Lidl Ballymun MetroLink Site

ABP-314724

Attachment 4: PUNCH Civil/Structural  
Engineering Report - Module 2

242119-PUNCH-XX-XX-RP-S-0001A

Figure 2: Imposed vertical loadings on cut & cover structures

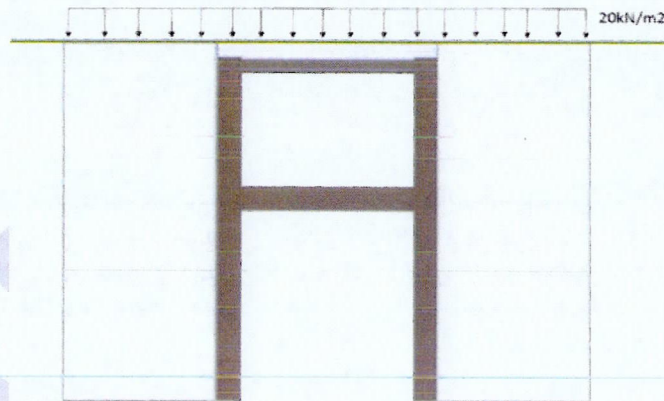
- a. The issued Draft Guidance Note for Developers is an important document from TII’s perspective as it sets out measures to protect the MetroLink substructure assets.
- b. The constraints set out in this document in relation to the development of the Lidl Ballymun site are extreme on two primary fronts. First, it sets out major limitations on vertical loading that can be imposed on the MetroLink Northwood station and connecting tunnels on the Lidl site. Second, the combined effect of development exclusion and protection zones appear to effectively render major parts of the Lidl site undevelopable.
- c. In relation to Loading Constraints, Figure 2 of the TII document is reproduced herein and shows an allowable surcharge load of 20kN/m<sup>2</sup>.

Considering the uniformly distributed load calculated from the proposed Lidl 15 storey structure on the site equates to  $210\text{kN/m}^2$  ( $165\text{kN/m}^2 + 45\text{kN/m}^2$ ) plus additional point and line loads - Refer Section 3A-D of this report - it is clear the proposed Lidl development cannot proceed if the loading conditions in this TII document are applied to the Lidl site.

Figure 7: Underground Station Protection and Exclusion Zones

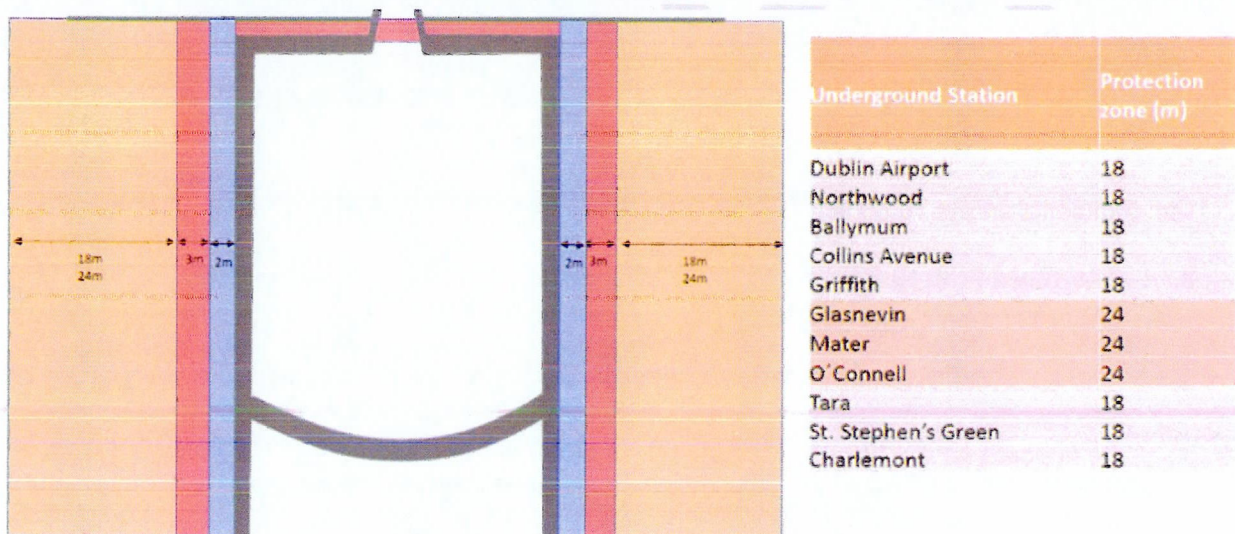
- d. In relation to zones of exclusion/protection relative to the TII station and tunnel assets, a number of diagrams are provided on scenarios where these would apply. For the purpose of this document, we reproduce Figure 7 of the TII document herein.

In effect for the station plus cut and cover tunnels on the Lidl site, no development can take place in this zone.

In this zone, work is permitted, but significant restrictions are in place on loading (20kN/m<sup>2</sup>) and constraints on foundation location, type etc.

Considering the extent of this zone at the Lidl site (2m deviation + 3m exclusion + 18m protection on both sides at Northwood station), the negative impact on the development potential of the Lidl site is extreme - Refer to Appendix C of this report for an illustrative layout prepared by MCA Architects.
